Access Compliance Report

Public Rights-of-Way

(Curb Ramps)

Intersection ID: 44081	Main Street: FOREST_RUN_LN	Cross Street: WESTMILL_LN	Location: NE
ADA ID: 4E8F220196D3	Ramp Type: BlendTrans1	Initial Pass/Fail: Fail	Overall Compliance: No
Severity Score: 35			
Codes/Mitigation Info/Possible Solution		Field Measurements/Component Compliance

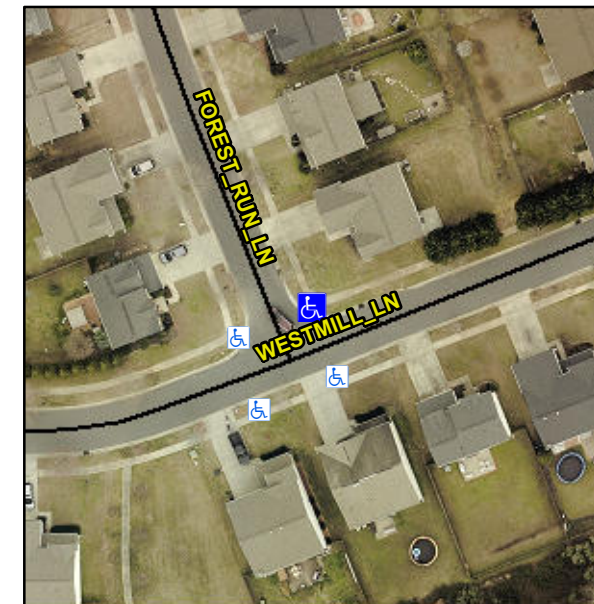
GTR GAP 7.0

Not Found, R304.5.1

Remove & Replace Curb Ramp With Two New Directional Ramps or Equivalent.
